Zilker Neighborhood Association

November 4, 2021

Re: Agenda item 56, Rezoning of 2700 South Lamar, Case C14-2020-0144

Figure 1

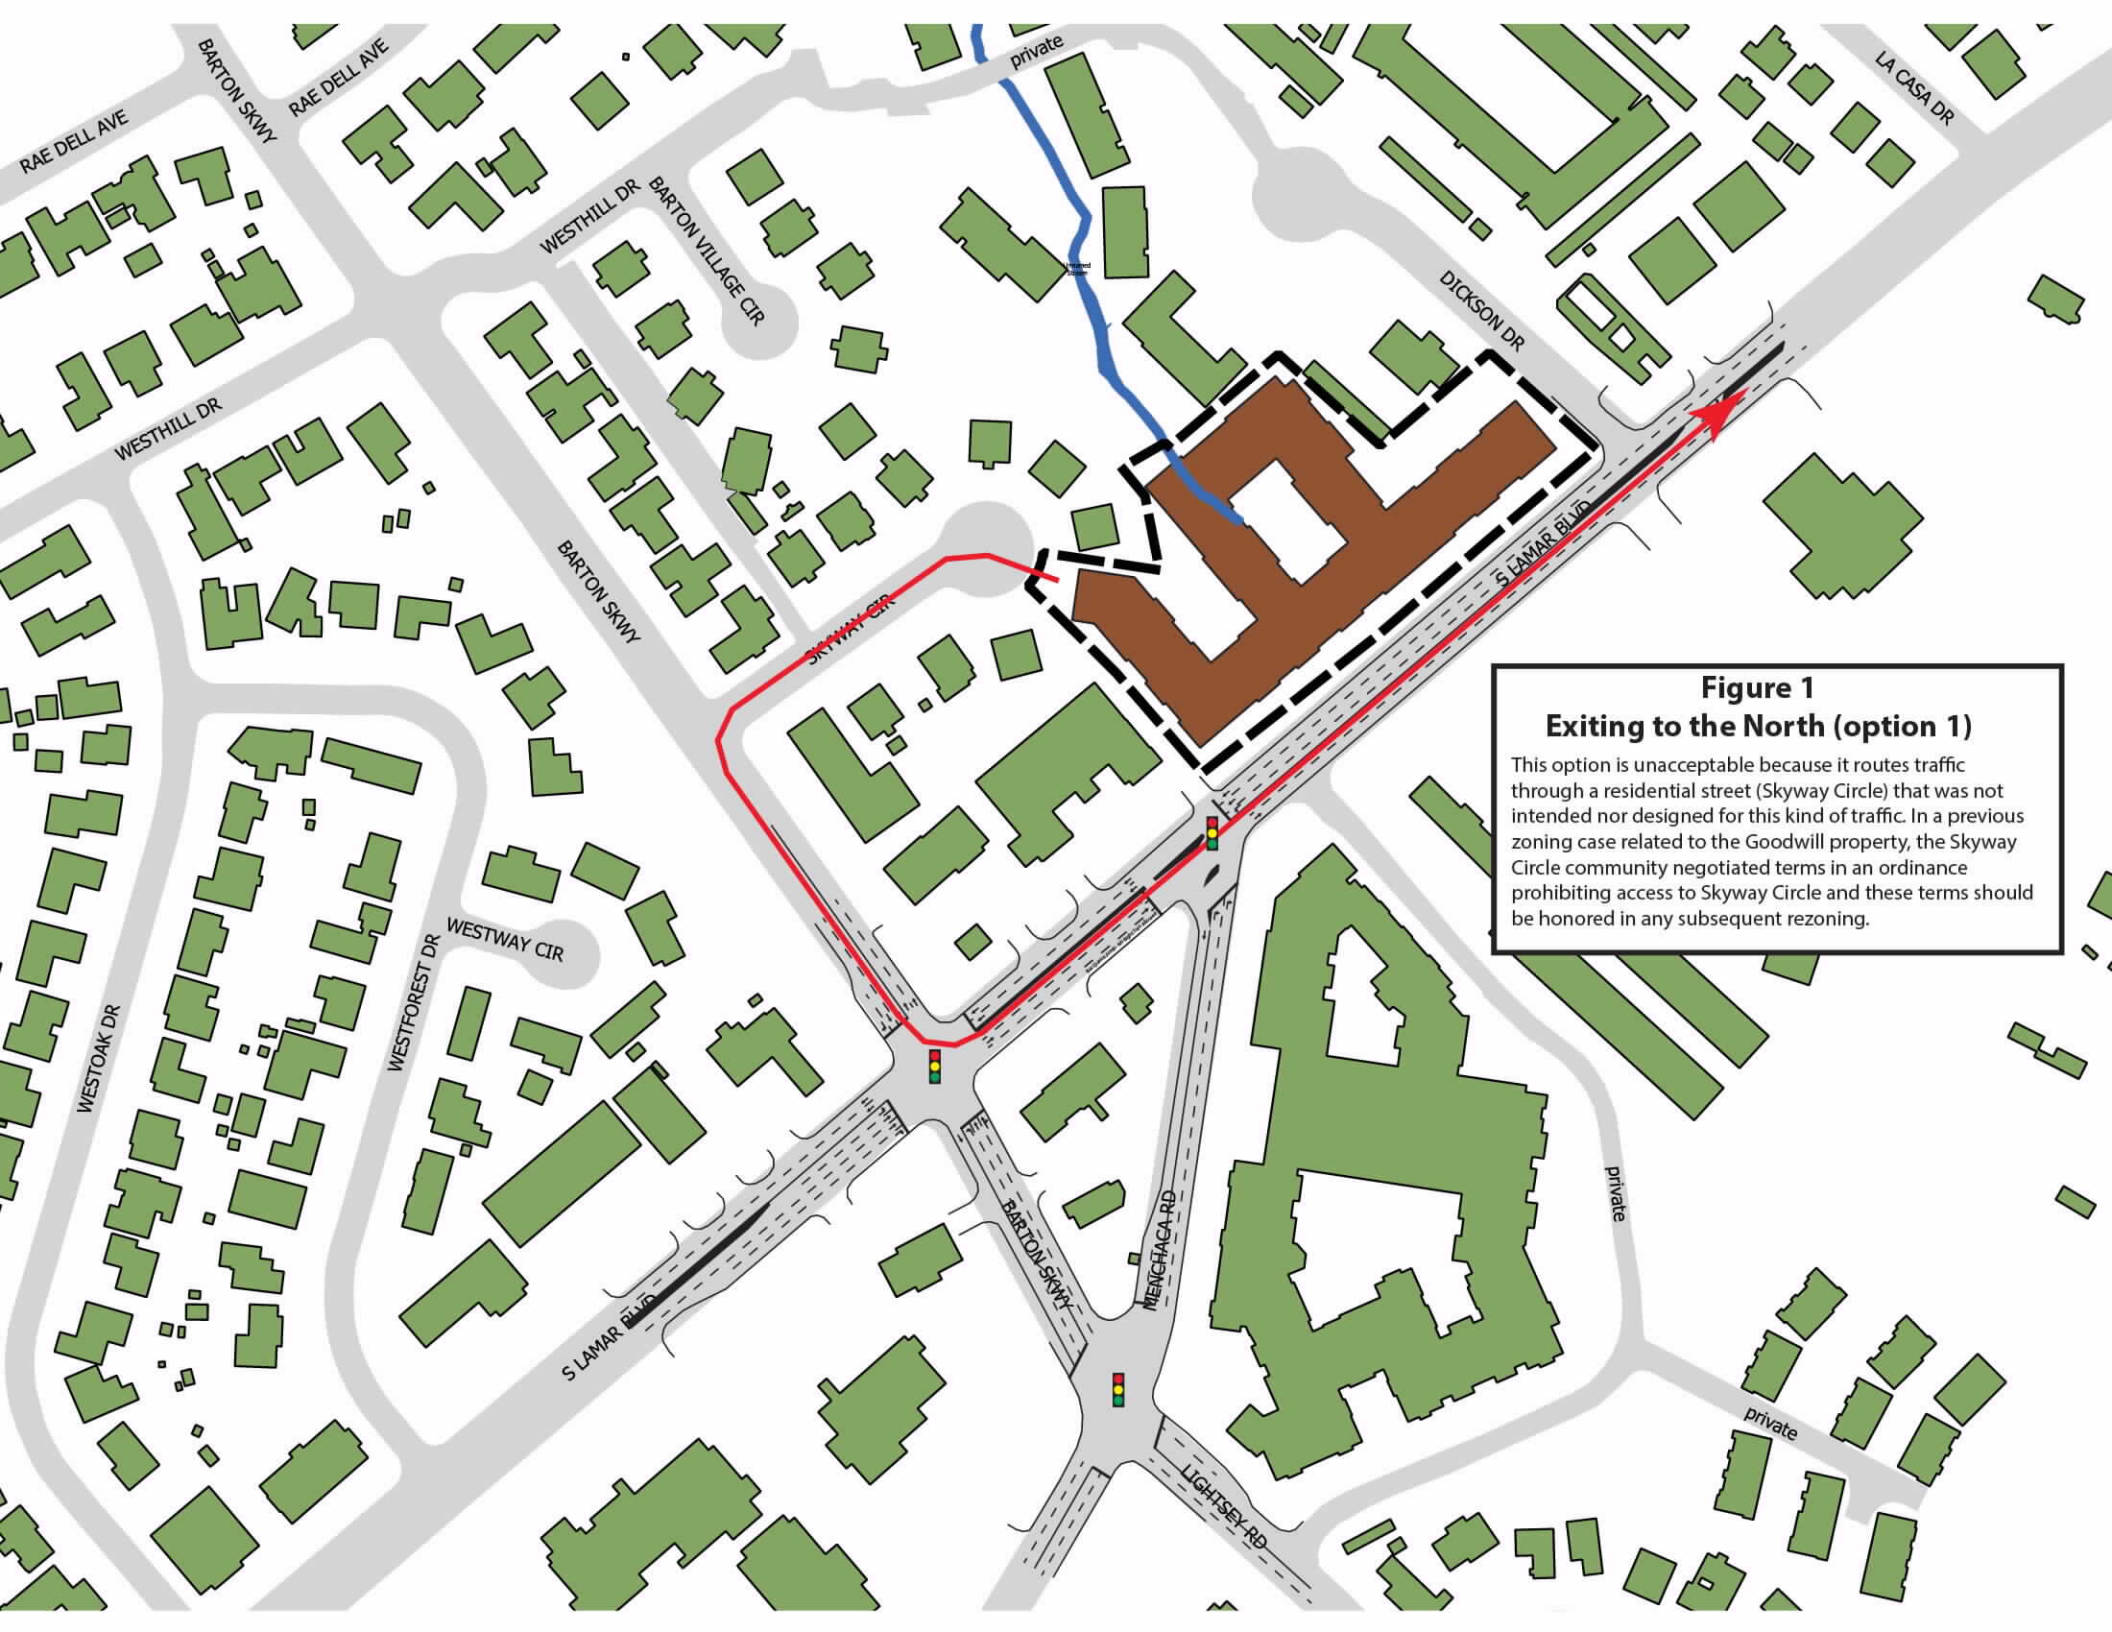
According to the South Lamar Corridor Improvements Plan, a traffic island at Dickson Drive will prevent left turns onto and off of South Lamar Blvd at this location. Figures 1 and 2 illustrate the difficulties that will face drivers exiting the property to the north. Northbound traffic entering the property from the south have a couple more choices but they are equally undesirable (and in some cases, illegal). Figures 3 through 5 illustrate three of them but there are also these two: 1) make a dangerous U-turn past the island into the southbound lanes or 2) force traffic through the neighborhood by turning left at the next light intersection (currently Bluebonnet) and take a circuitous route to Montclair St or La Casa Dr which will allow a right turn onto Lamar. None of these options are acceptable.

This option is unacceptable because it routes traffic through a residential street (Skyway Circle) that was not intended nor designed for this kind of traffic. In a previous zoning case related to the Goodwill property, the Skyway Circle community negotiated terms in an ordinance prohibiting access to Skyway Circle and these terms should be honored in any subsequent rezoning.

Figure 2
Exiting to the North (option 2)

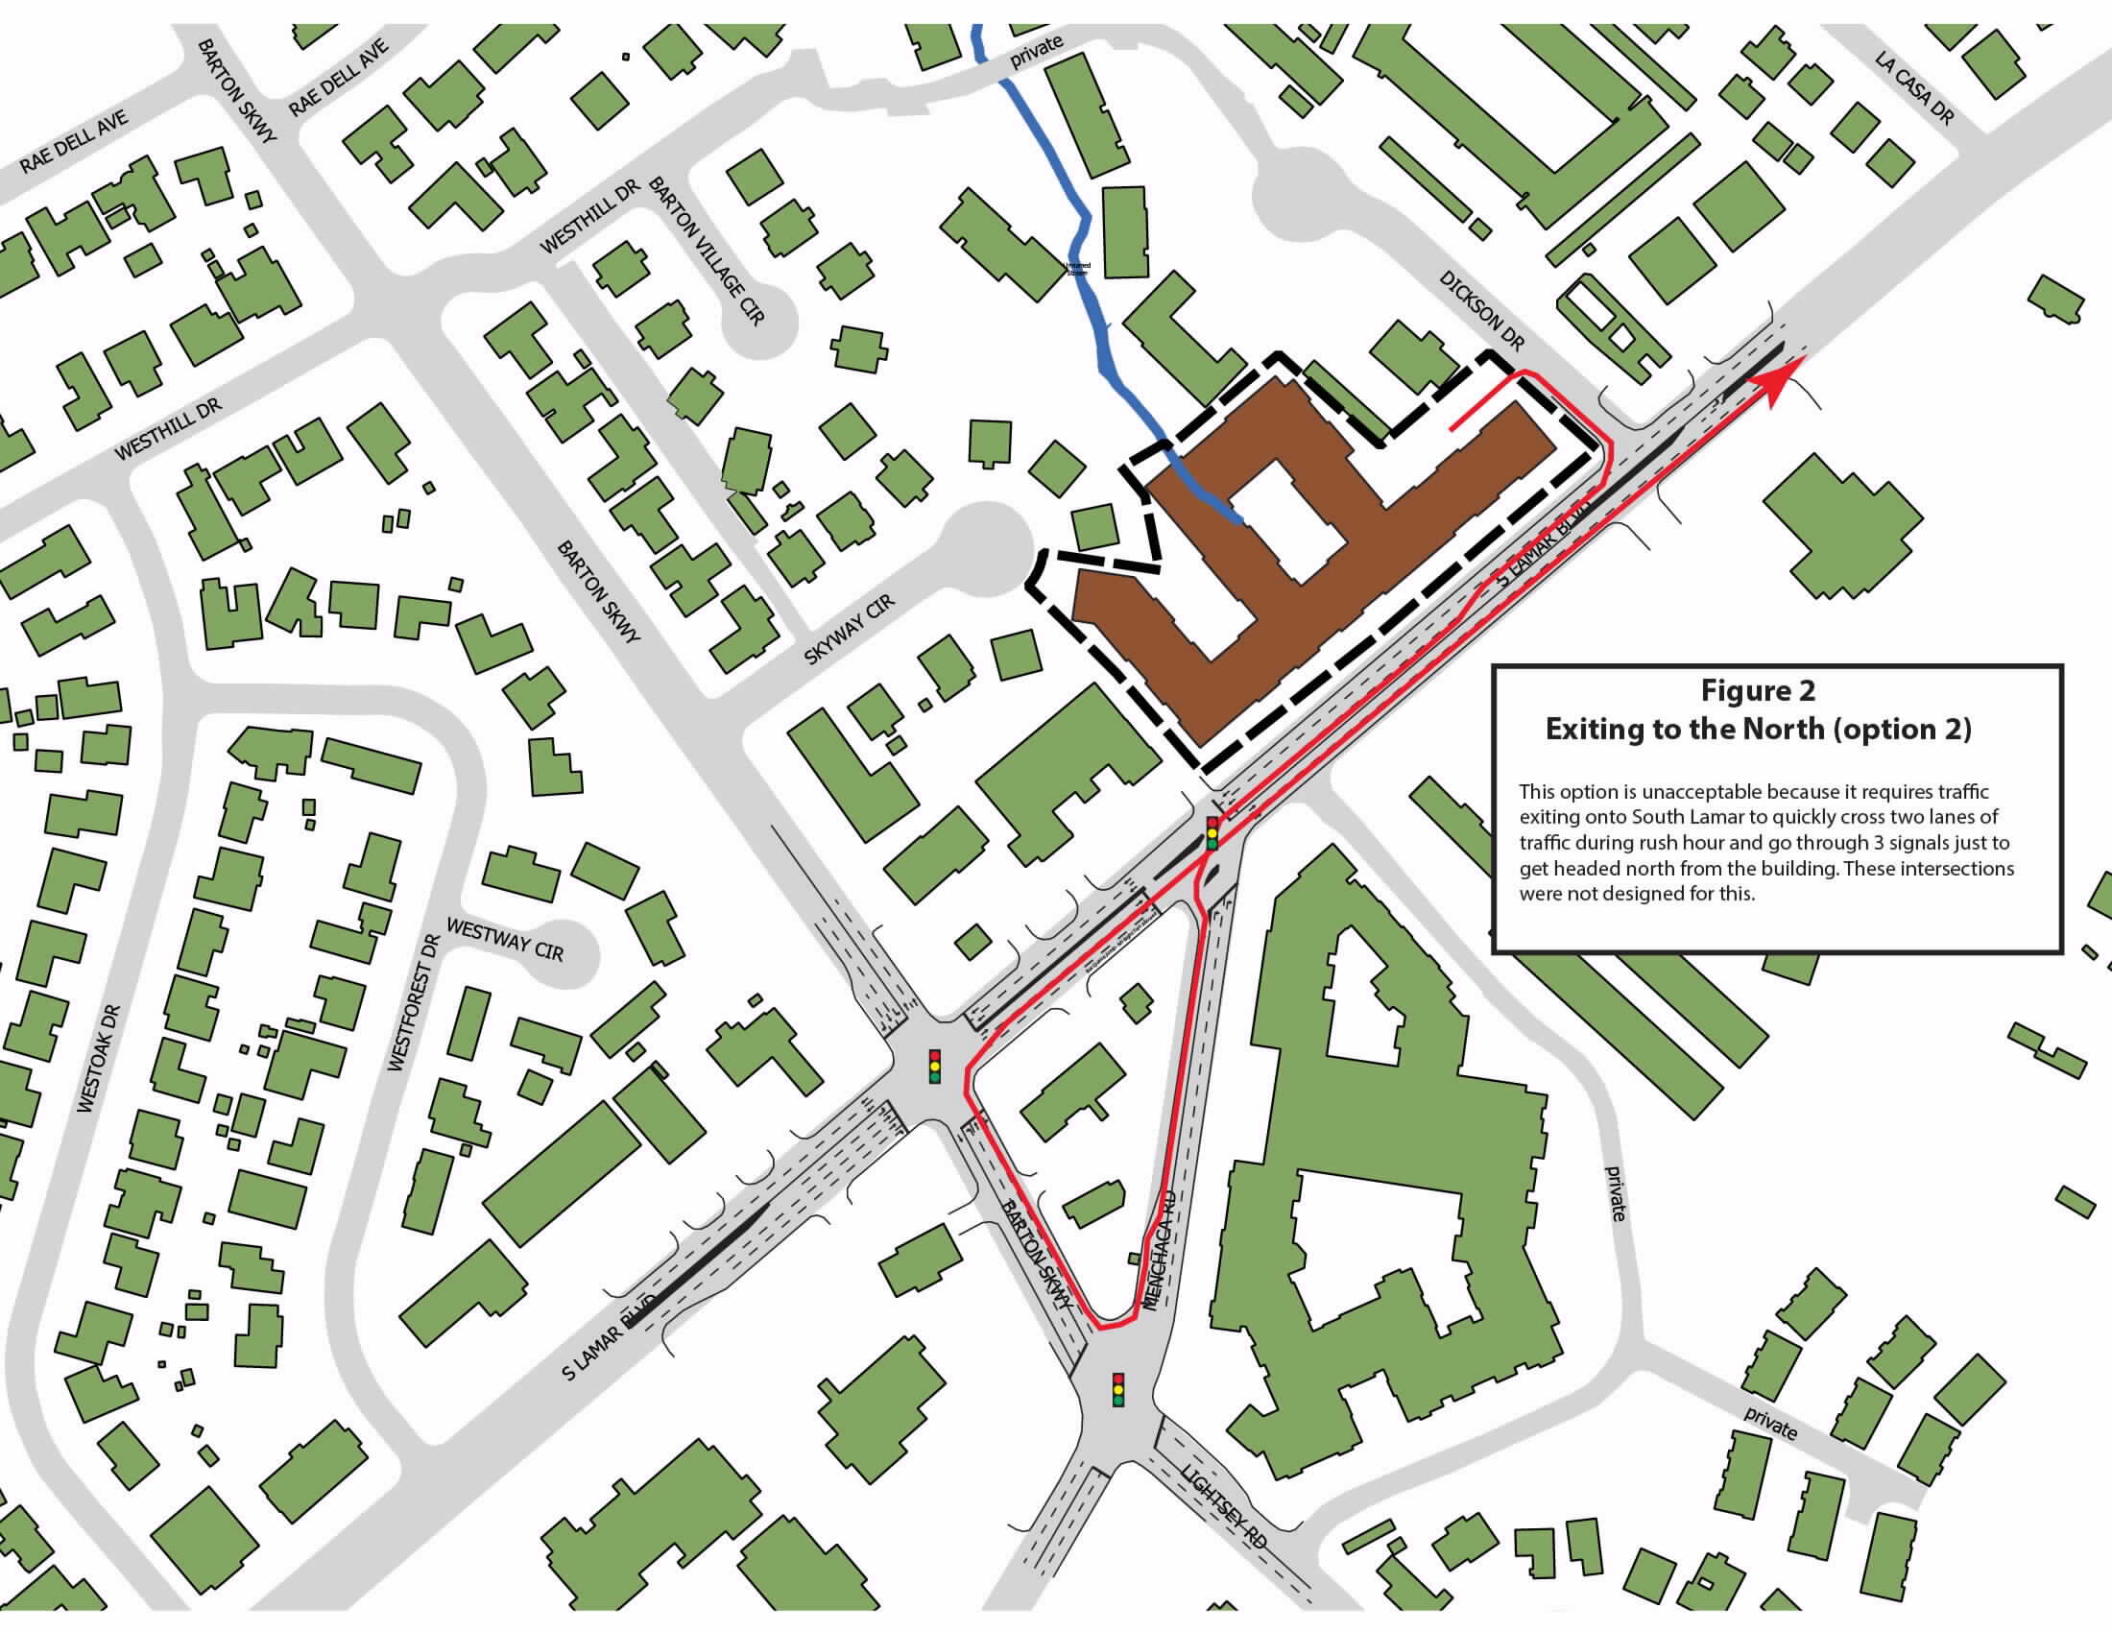
This option is unacceptable because it requires traffic exiting onto South Lamar to quickly cross two lanes of traffic during rush hour and go through 3 signals just to get headed north from the building. These intersections were not designed for this.

Figure 3

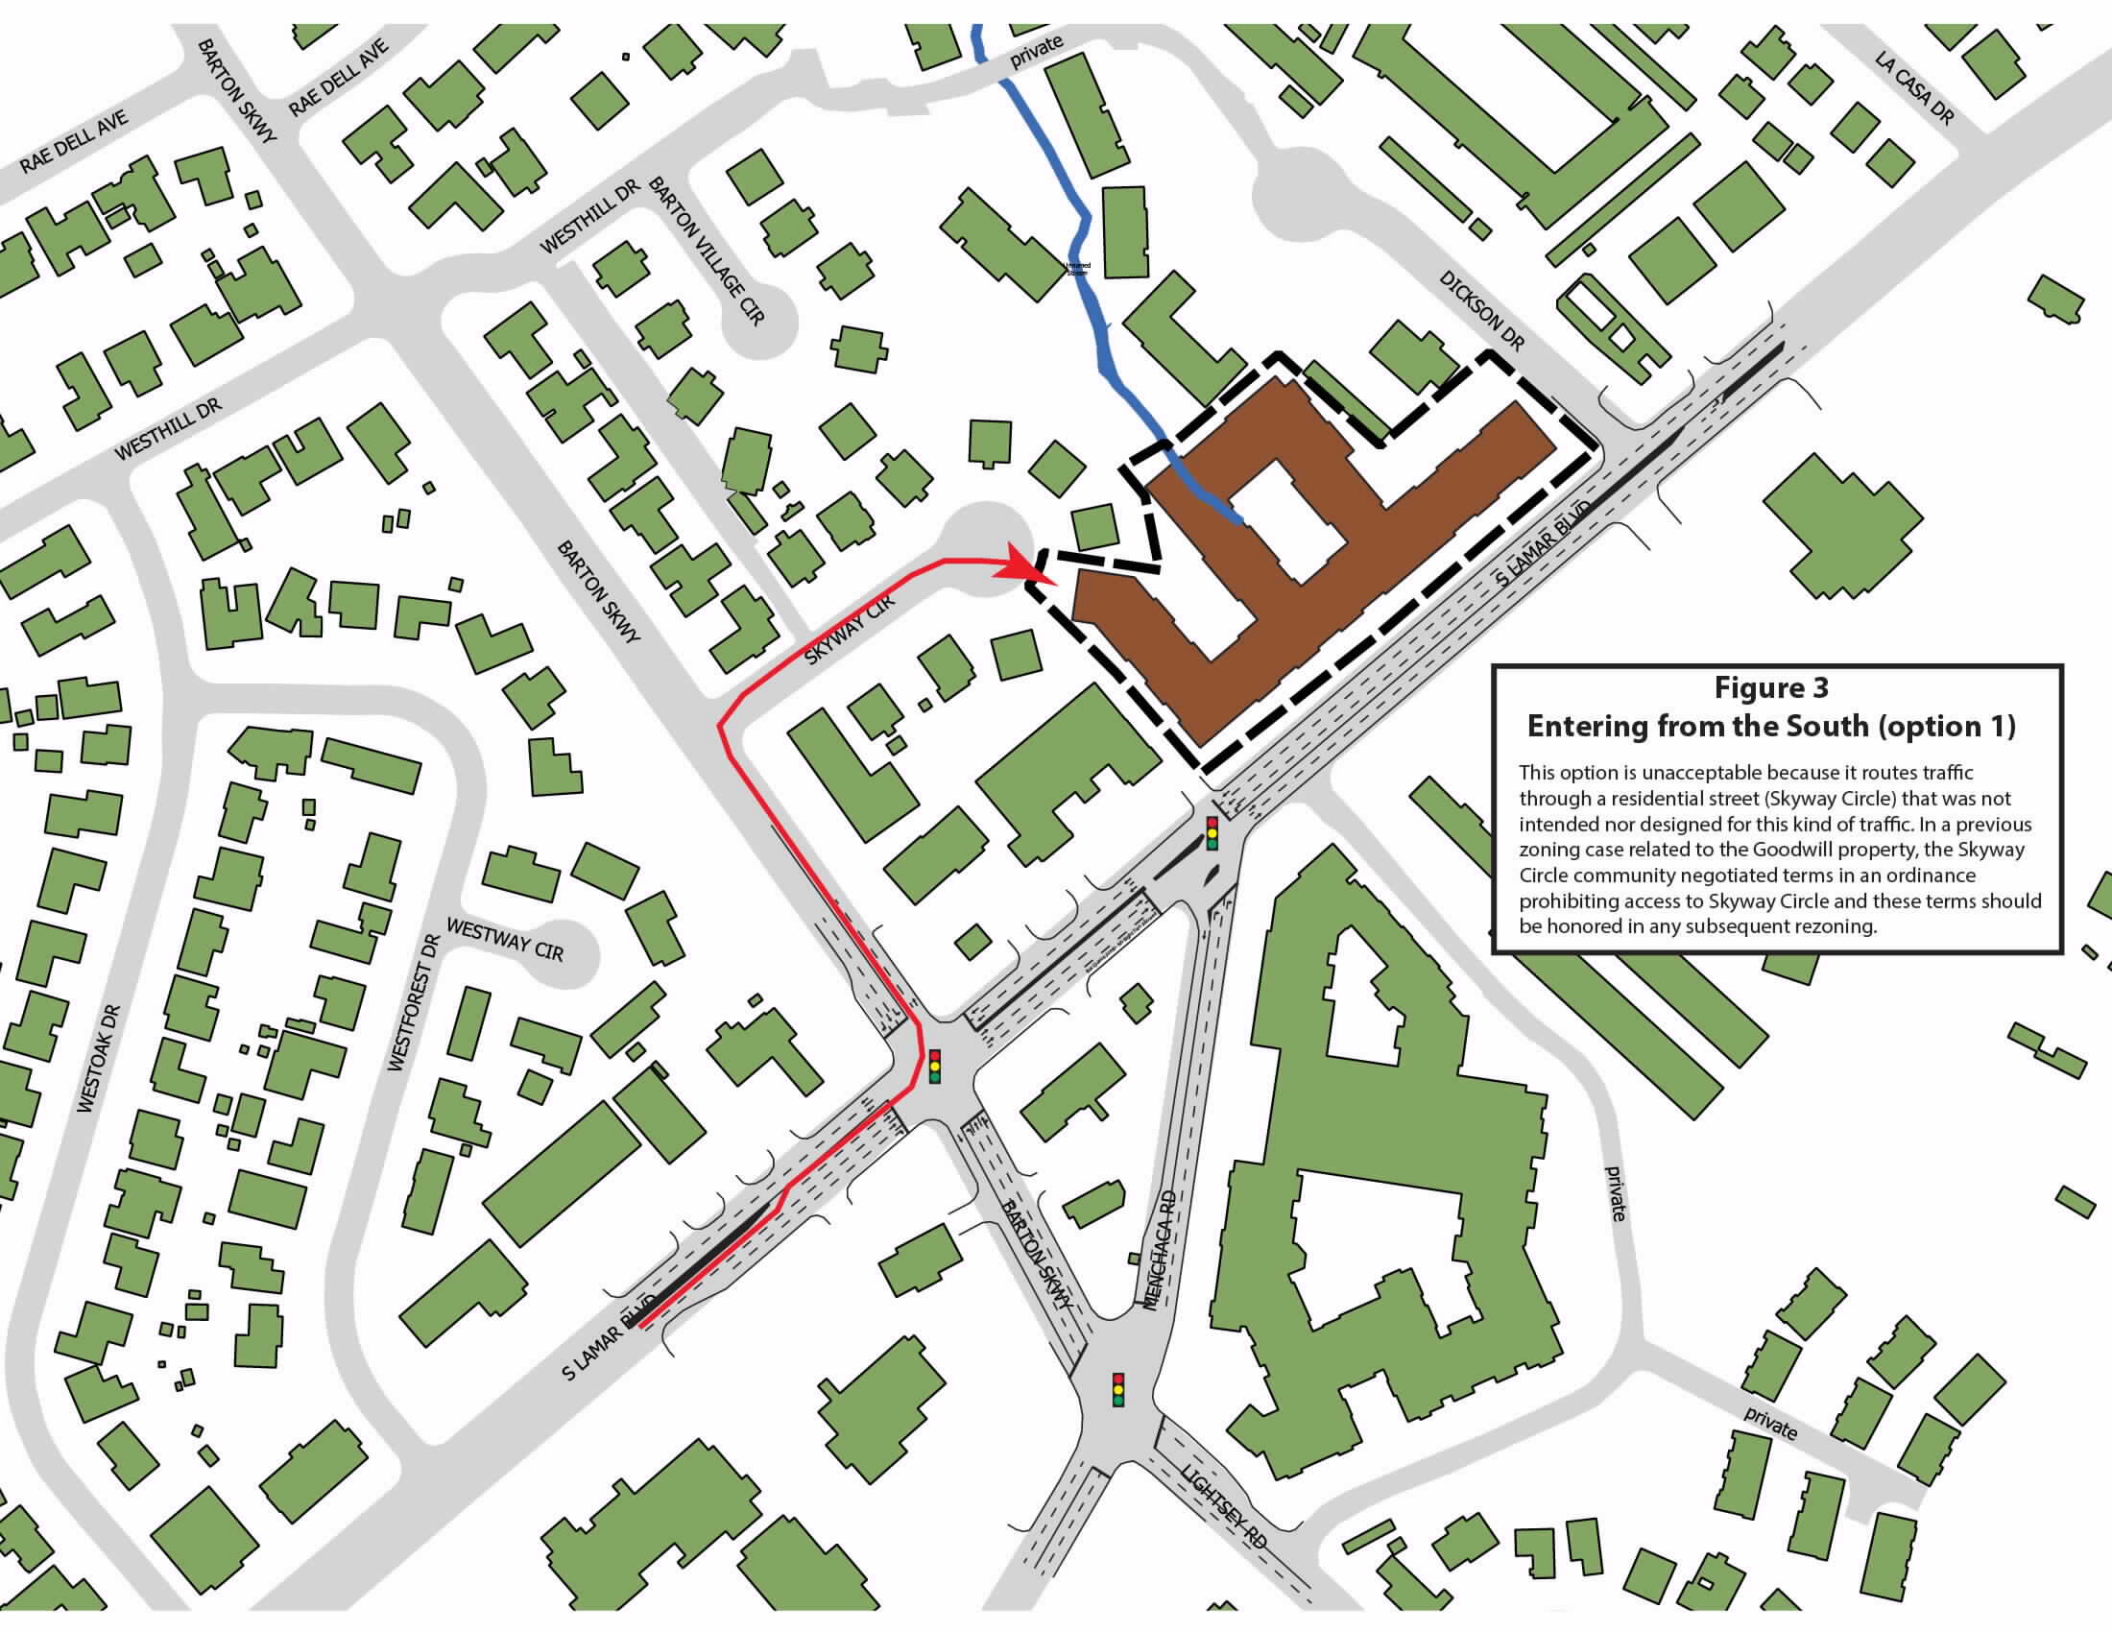
This option is unacceptable because it routes traffic through a residential street (Skyway Circle) that was not intended nor designed for this kind of traffic. In a previous zoning case related to the Goodwill property, the Skyway Circle community negotiated terms in an ordinance prohibiting access to Skyway Circle and these terms should be honored in any subsequent rezoning.
